Subject: Class II Permissive Change for PCB and Part Modification and PAG C2PCPCX

Product changes illustration and comparison

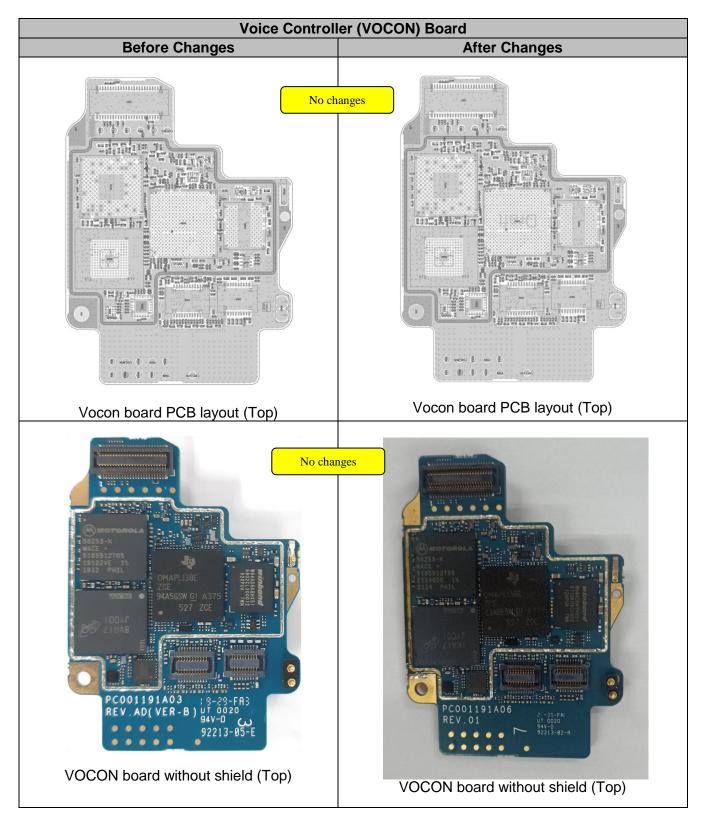
- 1. The changes were triggered due to BT/WLAN chipset part shortage and a new BT/WIFI chipset is replaced.
- Few passive components were replaced at Power Management section (PMIC), BT/WiFi Circuitry, 3.6V Switching Regulator and 3.3V LDO due to new BT/WLAN chipset part design requirement. All replacement parts performance are comparable to the existing parts.
- 3. There is no mechanical change.
- 4. No change to the sales model number.
- 5. Reuse shipping batteries, chargers and accessories.
- 6. No changes to the RF board.

* Changes are marked in yellow box. Orange box indicates the sections under the shield.
